Access Compliance Report

Public Rights-of-Way

Intersection ID: 49932	Main Street: WOBURN_RD	Cross Street: PAXTON_RUN_RD	Location: NE
ADA ID: 7E946A4B8EC4	Ramp Type: Perp	Initial Pass/Fail: Fail	Overall Compliance: No
		Severity Score: 22.5

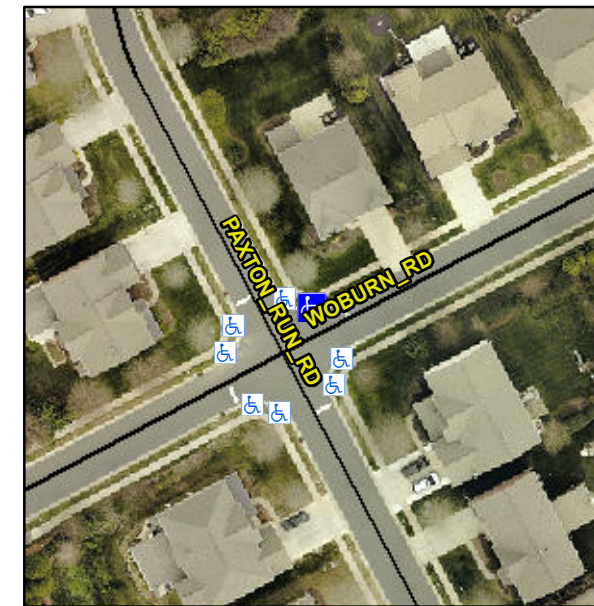
Not Found, R304.5.1, R304.2.2, R304.5.3

Compliance	Description	Data	Compliance	Description	Data
N/A	Ramp Length (in)	47.0	No	Ramp Slope (%)	10.2
No	Ramp Width (in)	47.0	No	Ramp XSlope (%)	3.2
N/A	Flare Type LT	N/A	N/A	Flare Type RT	N/A
N/A	Flare Slope LT (%)	N/A	N/A	Flare Slope RT (%)	N/A
N/A	Flare Traversable LT?	N/A	N/A	Flare Traversable RT?	N/A
N/A	Landing Length (in)	N/A	N/A	DWS Provided?	N/A
N/A	Landing Width (in)	N/A	N/A	DWS Contrast?	N/A
N/A	Landing Slope (%)	N/A	N/A	DWS Length (in)	N/A
N/A	Landing X Slope (%)	N/A	N/A	DWS Full Width?	N/A
N/A	Landing Curb? (Y/N)	N/A	N/A	DWS Offset (in)	N/A
N/A	Shared Landing?	N/A			
N/A	Gutter Ponding?	N/A	N/A	Gutter Slope (%)	N/A
N/A	Gutter Lip Ht (in)	N/A	N/A	Gutter X Slope (%)	N/A
N/A	Painted X Walk1?	No	N/A	Painted X Walk2?	N/A
	X Walk 1 Direction	To SE		X Walk 2 Direction	N/A
N/A	X Walk 1 Width (in)	N/A	N/A	X Walk 2 Width (in)	N/A
	X Walk 1 Slope (%)	1.0		X Walk 2 Slope (%)	N/A
	X Walk 1 X Slope (%)	4.0		X Walk 2 X Slope (%)	N/A

Remove & Replace Entire Ramp.
